**EN010125: Application by RWE Renewables UK Dogger Bank South (West) Limited and RWE Renewables UK Dogger Bank South (East) Limited for the Dogger Bank South Offshore Wind Farms Project**

**The Examining Authority's Written Questions and requests for further information**

**Issued on 28 February 2025**

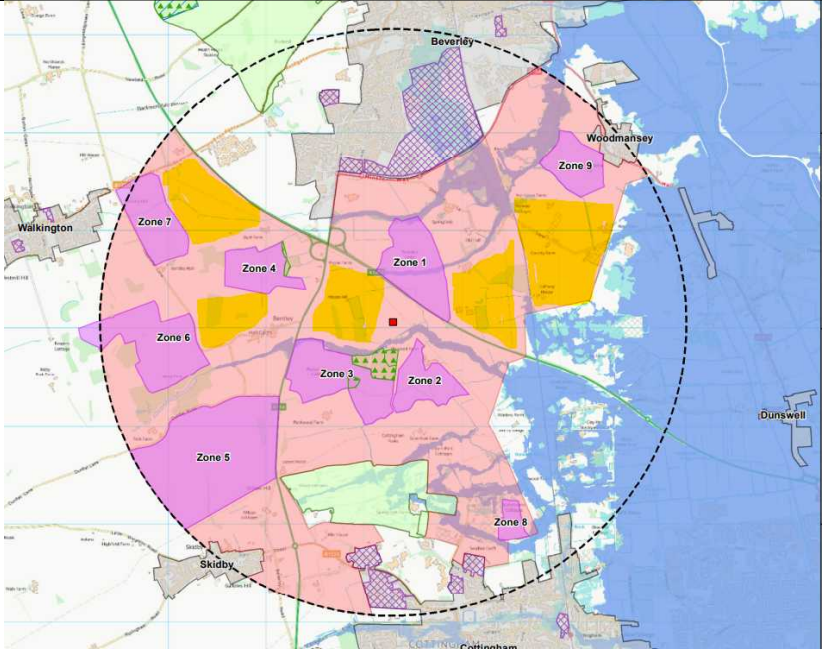
GD.1.6	The Applicants	<b>Design and Access Statement</b> The DAS <a href="#">[REP2-027]</a> , Plate 4-7] shows the proposed converter stations with the larger footprint prior to Change Request 2. Can you update this plate, and review and update any others in the document that show the larger converter station footprint?
GD.1.7	The Applicants	<b>Infrastructure security</b> What consideration have you given to the protection of the proposed onshore and offshore infrastructure from acts of vandalism and the threat of terrorist attack?
GD.1.8	The Applicants	<b>The Holford and Horlock Rules</b> ES Chapter 4 <a href="#">[AS-017]</a> , Table 4-1] refers to the Holford and Horlock Rules as applicable to the Proposed Development. With references to NPS EN-5 paragraphs 2.9.17 and 2.9.19, can you set out in detail how the Holford and Horlock Rules informed and influenced your site selection for the Proposed Development?

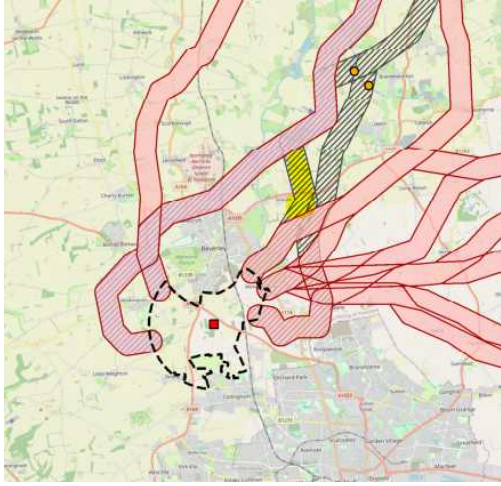
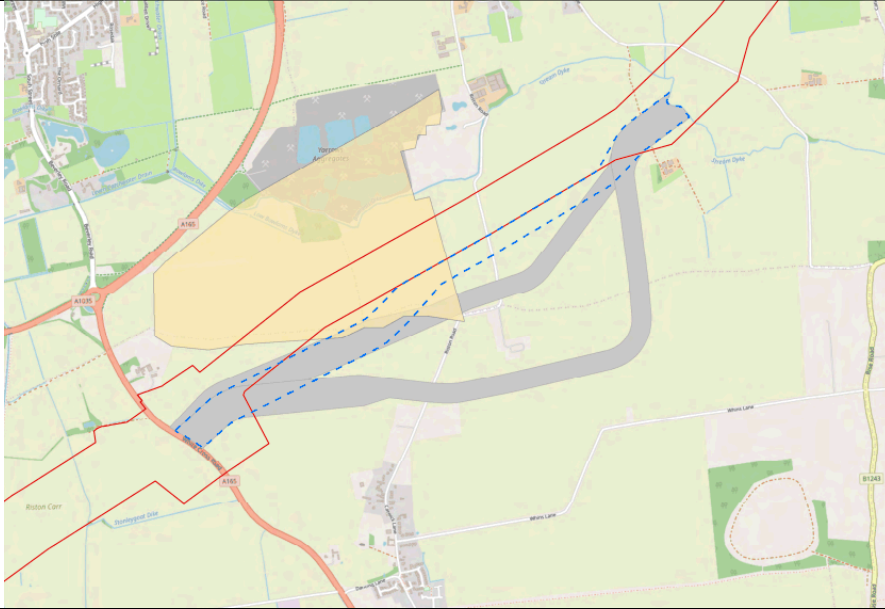
GD.1.13	The Applicants	<b>Site selection – converter stations</b> Why were the areas highlighted in orange below not included in the substation zone long list (map taken from <a href="#">[AS-011]</a> ):
